APPLICATION FOR APPROVAL OF CONSTRUCTION CHANGE DOCUMENT – CCD CATEGORY A

School District/Owner: Davis Joint Unified School District	DSA File #: 57 - 11
Project Name/School: Cesar Chavez Elementary School	DSA App. #: 02 - 114122

APPLICANT		
CCD #: 005	Date Submitted: 9-22-2015	Attached Pages?: <input type="checkbox"/> No <input checked="" type="checkbox"/> Yes (5 pages)
Firm Name: HMC Architects	Contact Name: Raija Clar	
Email: raija.clar@hmcarchitects.com	Phone Number: (916) 325-1100	
Address: 2495 Natomas Park Drive, Studio 655		
City: Sacramento	State: CA	Zip: 95833
<input type="checkbox"/> A DSA 301-N, DSA 301-P, or 90-Day Letter has been issued for this project.

CHECK THIS BOX: <input type="checkbox"/> To confirm that all CCD drawings and calculations have been stamped and signed by the Responsible Design Professional.
Brief description of construction change (attach additional sheets if needed): Per field trip note CS-01 by Lucinda Johnson existing toilet rooms to be revised to be accessible and existing roof eave to be revised to allow accessible path of travel.
List of DSA approved drawings affected by this CCD: A1.1

PLUMBING FLOOR PLAN - BLDG D

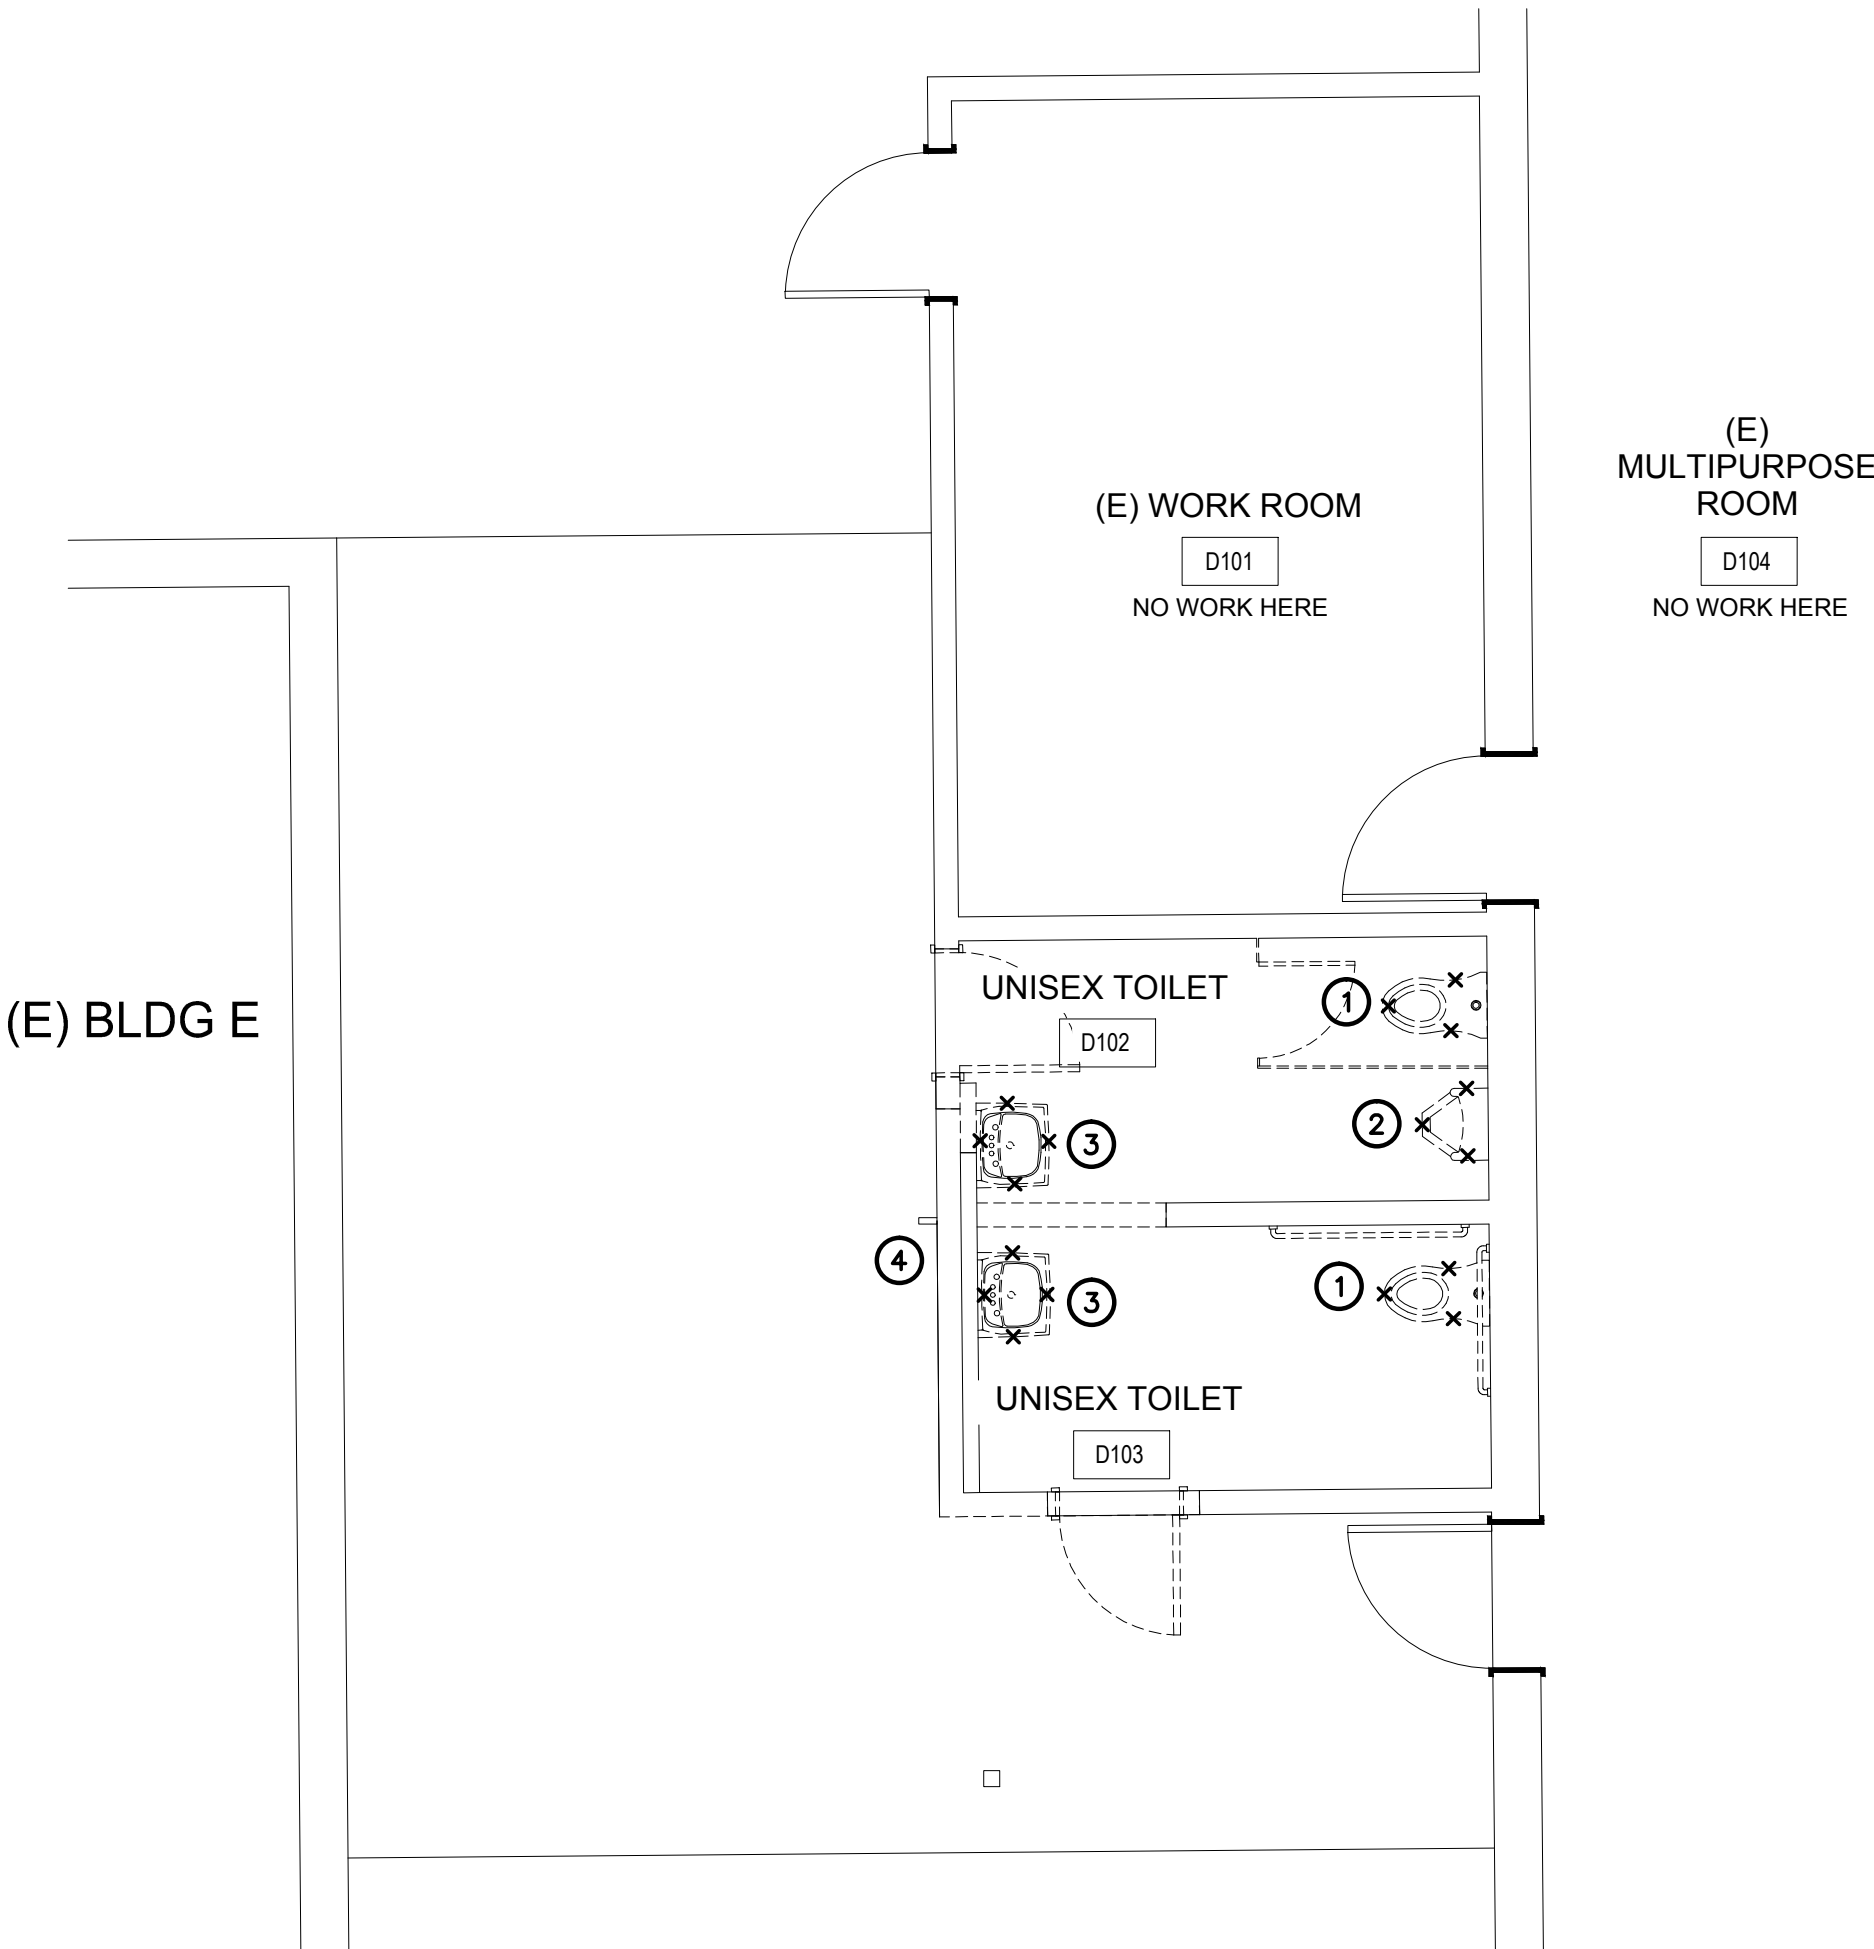
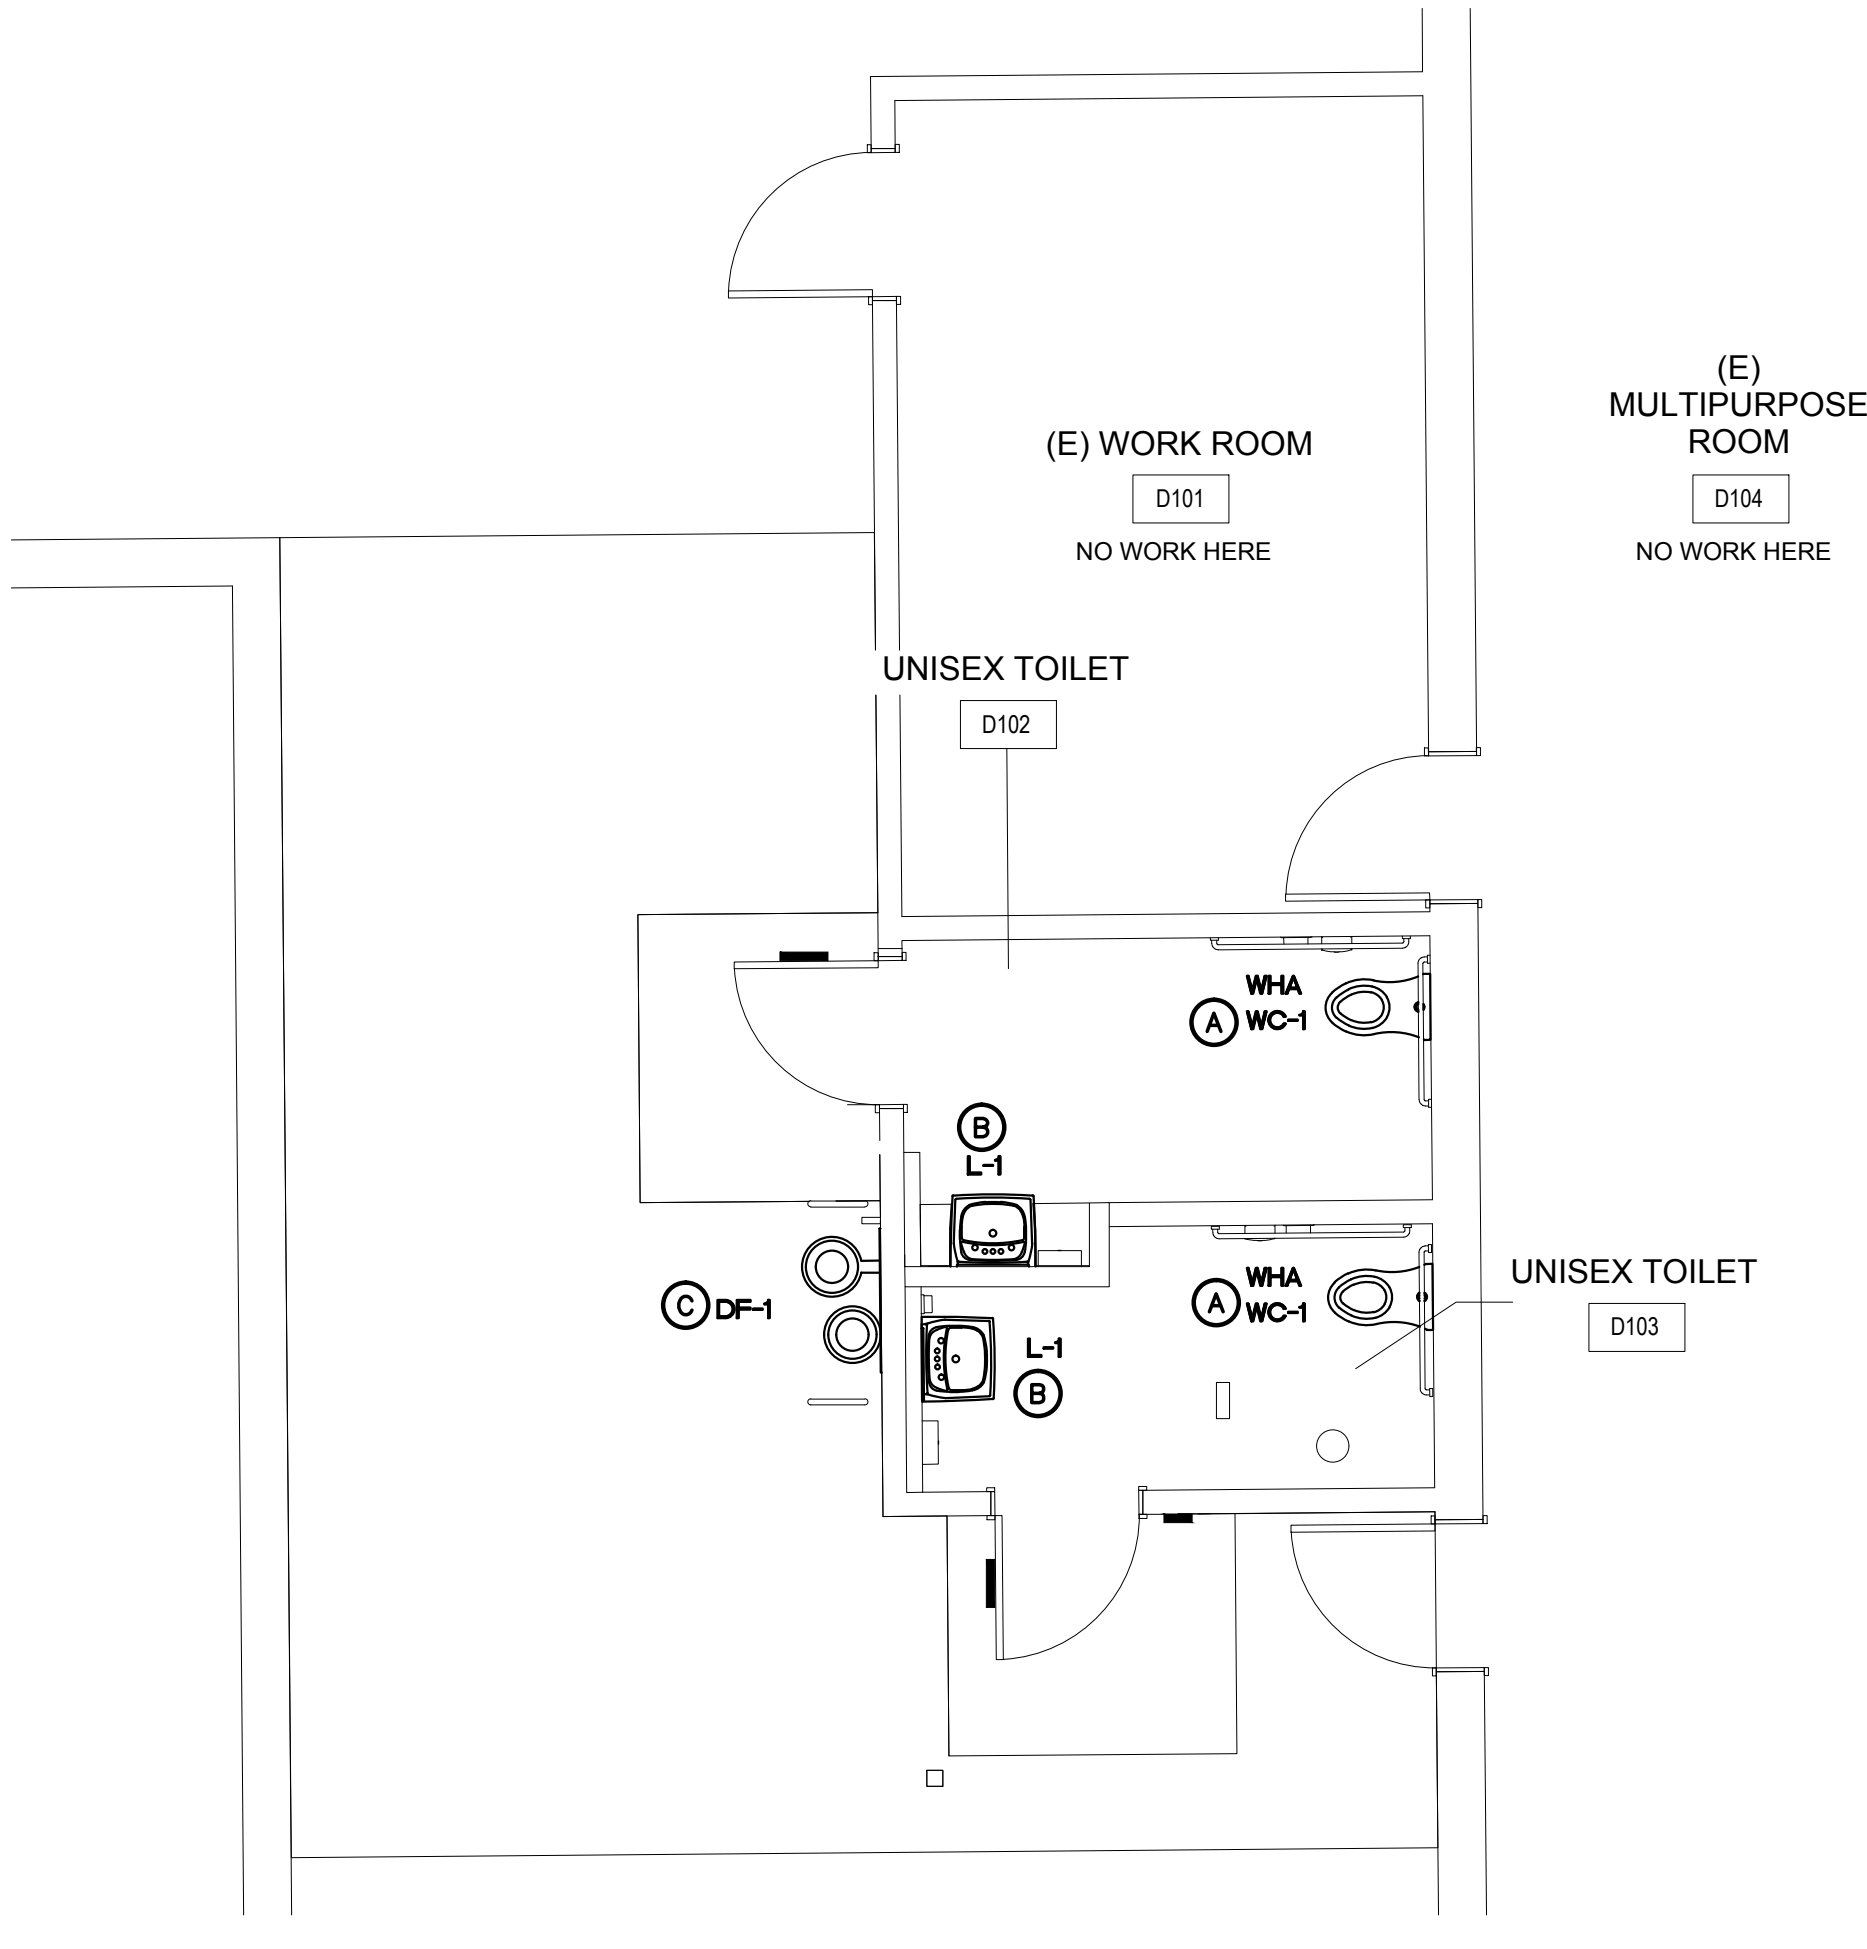
- 1 EXISTING WATER CLOSET TO BE REMOVED AND REPLACED WITH NEW. ADJUST EXISTING PIPING TO ACCOMMODATE NEW ROUGH-IN REQUIREMENTS OF REPLACEMENT WATER CLOSET.
- 2 EXISTING URINAL TO BE REMOVED. CAP UNUSED PIPING ABOVE, BELOW OR BEHIND ARCHITECTURAL FINISHES.
- 3 EXISTING LAVATORY TO BE REMOVED AND REPLACED WITH NEW. ADJUST EXISTING PIPING TO ACCOMMODATE NEW ROUGH-IN REQUIREMENTS OF REPLACEMENT LAVATORY.
- 4 EXISTING DRINKING FOUNTAIN TO BE REMOVED AND REPLACED WITH NEW. ADJUST EXISTING PIPING TO ACCOMMODATE NEW ROUGH-IN REQUIREMENTS OF REPLACEMENT DRINK FOUNTAIN. (E) DRINKING FOUNTAIN HAS ALREADY BEEN REMOVED, ONLY PIPING IS LEFT EXPOSED.

- A NEW WATER CLOSET TO BE CONNECTED TO EXISTING PIPING ADJUSTED TO NEW ROUGH-IN LOCATION.
- B NEW LAVATORY TO BE CONNECTED TO EXISTING PIPING ADJUSTED TO NEW ROUGH-IN LOCATION.
- C NEW DRINKING FOUNTAIN TO BE CONNECTED TO EXISTING PIPING ADJUSTED TO NEW ROUGH-IN LOCATION.
